1020000 MAINTENANCE OF TRAFFIC
COMMENTS FROM INTERNAL/INDUSTRY REVIEW

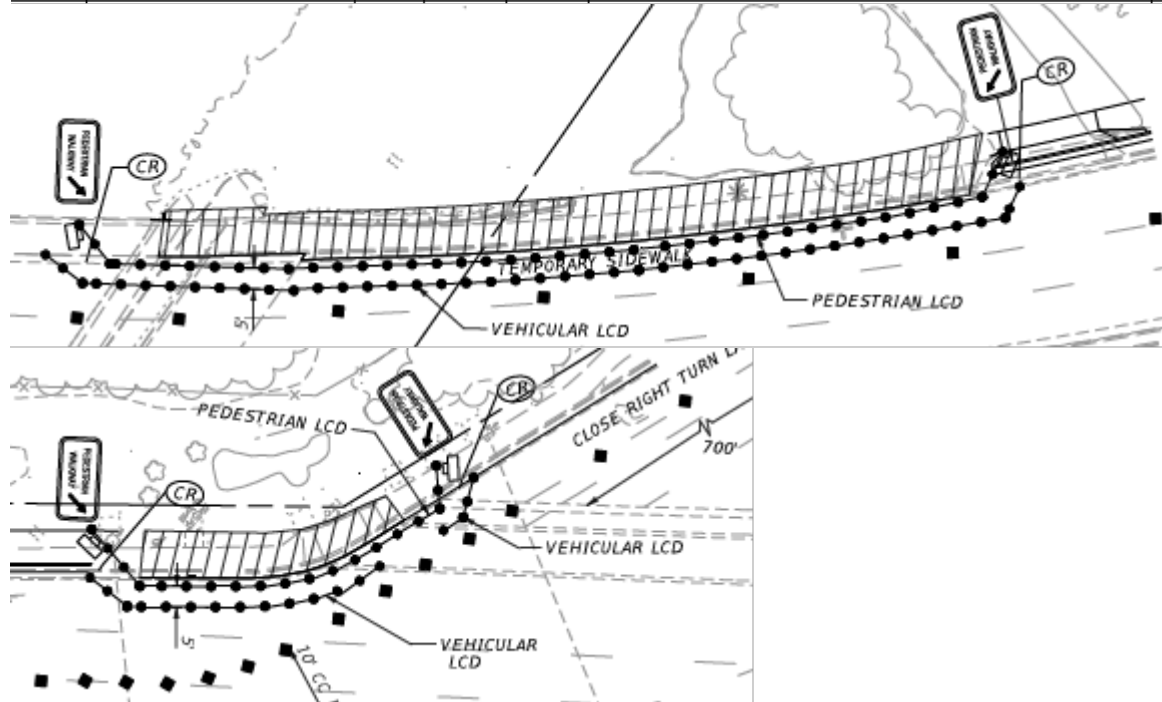
Thirdly, Under 102-9 Temporary Traffic Control Devices; the link for the Pedestrian LCD shows a photo of the LCD with reflective sheeting. This has been discussed and agreed upon to remove reflective sheeting as to that it does not benefit the visual impaired pedestrian.

Fourthly, Under 102-9.5 Channeling Devices the last sentence in part reading "...provide barrier delineators on the top surface of the pedestrian LCDs in accordance with Section 705." This is an inappropriate request since the pedestrian LCD's do not need this type of marker and it will impede the actual guidance surface that these were intended to provide for the visually impaired.
